## Questions and Answers concerning the Corner Bay Prospectus

October 9, 2015

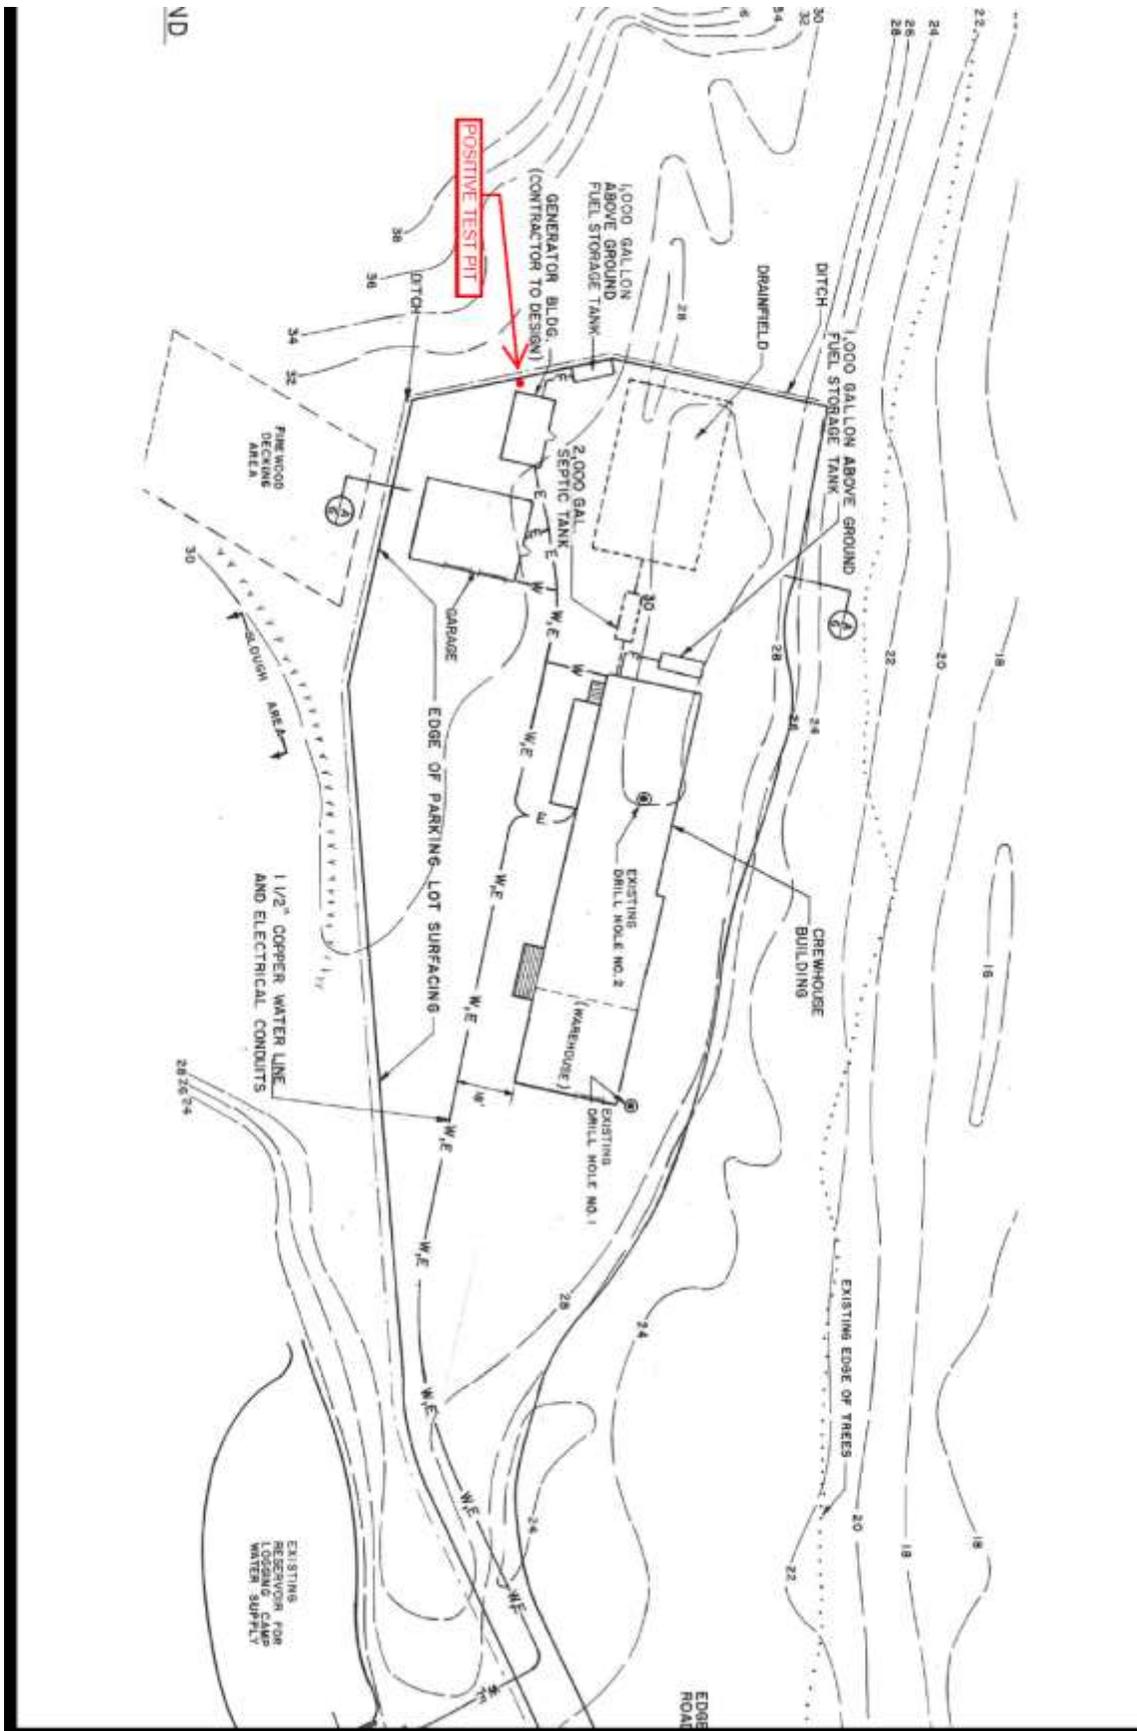
*On page 8, the prospectus provides for the permit holder to maintain two existing above-ground fuel tanks. Will the USFS agree to include appropriate language in the permit to make clear that the permit holder does not assume any liability in connection with any pre-existing spills or other conditions associated with the operation and maintenance of the tanks and associated infrastructure prior to the permit holder's use or occupancy of the site?*

**Answer** - No surveys have been conducted for fuel contamination associated with the operation and maintenance of the tanks or associated infrastructure to date. The Forest Service plans to complete site file research and basic field screening at the site this fall.

**Result of the field screening is as follows:**

A preliminary site investigation of the Corner Bay Admin site and the separate bulk fuel storage area was performed on 10/1/15 and 10/2/15. Test pits were hand excavated at 12 locations. Test pit locations were determined by proximity to, and relative elevation from, historic and existing fuel storage tanks, fuel lines, and fuel dispensing areas. Six test pits were excavated at the Administrative site, and six test pits were excavated at the bulk fuel storage area. Test pit depths varied from 14 to 30 inches below adjacent grade. Field screening samples were collected at each test pit and analyzed via heated head space field screening procedures, performed with a photoionization detector. The presence of organic vapors, suspected to be petroleum, was detected at one test pit, at a depth of 18 inches below adjacent grade. This positive test pit was located adjacent to the west corner of the Generator Building. Organic vapors were not detected at the test pit approximately 15 feet downgradient of the positive test pit, nor were they detected at any other test pit. A sheen was not detected in the ditch adjacent to the positive test pit. Therefore, it is assumed that the positive field screening result is due to historic spill(s) of less than 10 gallons and static in nature, assumed to be related to the exterior fuel/water separator on the diesel fuel line between the Generator Building and the incinerator. Investigation of the beaches down gradient of the Administrative site and the bulk fuel storage area did not detect oil sheens, odors, or other signs of contamination. A map of the site is attached below.
